AGENDA
CITY OF LAKE WORTH BEACH
HISTORIC RESOURCES PRESERVATION BOARD REGULAR MEETING
BY TELECONFERENCE
WEDNESDAY, JANUARY 13, 2021 -- 6:00 PM

MEMORANDUM DATE: January 6, 2021

TITLE: **HRPB Project Number 20-00100233:** A Certificate of Appropriateness for the construction of a ± 3,685 square foot multi-family building located at **207 Ocean Breeze (Block 95, Lot 11)**, pursuant to but not limited to Sections 23.2-7, 23.3-10, and Section 23.5-4 of the Land Development Regulations. The subject property is located in the Multi-Family (MF-20) Zoning District and is located within the South Palm Park Local Historic District.

Existing Flat Concrete Tile Roof

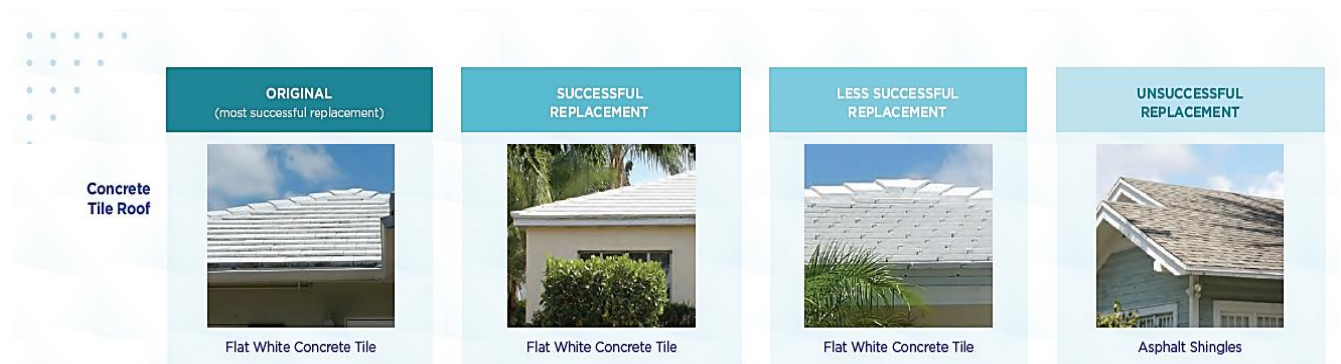
It is the analysis of Staff that the proposed change to dimensional asphalt shingles in white could negatively affect the character-defining feature of the property. This style of architecture primarily used flat white concrete tiles as a roofing material, and occasionally used an asbestos shingle, asphalt shingle, or rolled roofing. The Historic Preservation Architectural Style Section for Minimal Traditional Structures is included as **Attachment C**. Utilizing dimensional asphalt shingles in white on a Masonry Minimal Traditional structure is a significant departure in profile and design. Masonry residential structures throughout Lake Worth Beach were designed with an emphasis placed on horizontality. The buildings are typically linear in appearance, often one story, and utilized horizontal details in windows and doors. The roofing materials for these buildings continued this theme, with thick concrete tiles laid in horizontal rows creating a visually stepped appearance towards the high point of the roof.
